## SHOCK ABSORBER AND FRONT SHOCK MOUNT

The purpose of this bulletin is to announce the release of a **new** shock absorber kit for all 1995-2000 S1, S1W, M2, S2/S2T, S3/S3T, and X1 Model Buell motorcycles and to provide installation and adjustment instructions. Buell Motorcycle Company has developed this kit as an upgrade to the shock absorbers currently in use.

Since the release of the original bulletin, the spring preload locknut tightening procedure has been modified (as covered in Bulletin B-037). This bulletin includes the new torque specification and tightening procedure.

Figure 2. New Shock Absorber Assembly

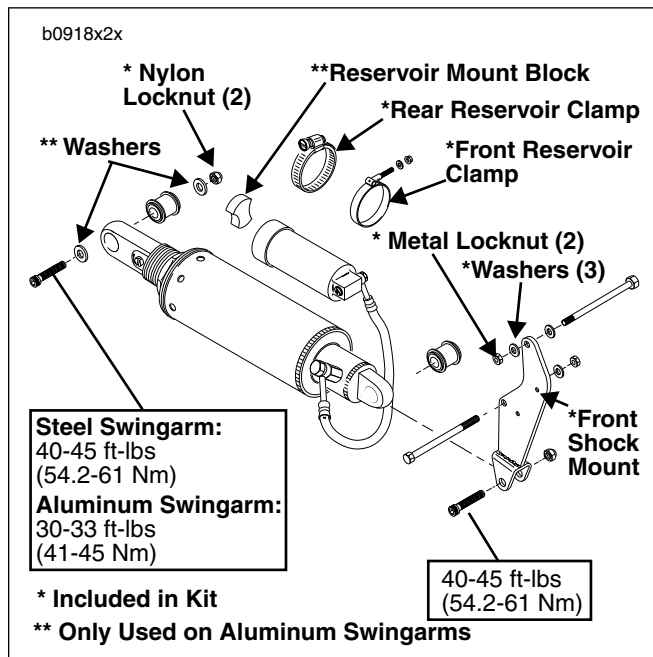
The new front shock mount **MUST** be used with the new shock absorber. The new shock is 1.77 in. (45 mm) shorter than the previous shocks and requires the new front mount to align and install properly.

- See Figure 2. Install **new** front shock mount to crankcase with two **new** front shock mount bolts, washers, star washer (on 1997 M2, S3/S3T models only) and metal locknuts. Tighten bolts to 30-33 ft-lbs (41-45 Nm). NOTE: Top bolt goes in from the left side, bottom bolt goes in from right side. Bottom bolt does not use washer under bolt head. Star washer (only used on 1997 M2, S3/S3T models) goes on bottom bolt under the washer on the nut side. If exhaust was loosened during front shock mount removal, replace exhaust gaskets and reinstall exhaust. See appropriate Service Manual, Section 2 for instructions.
- All Models Except S1/ S1W/S2/S2T:** Apply LOCTITE THREADLOCKER 243 (Blue) to threads of **new** button head fastener. Fasten voltage regulator bracket to front shock mount with **new** small button head fastener. Tighten fastener to 5-6 ft-lbs (7-8 Nm).
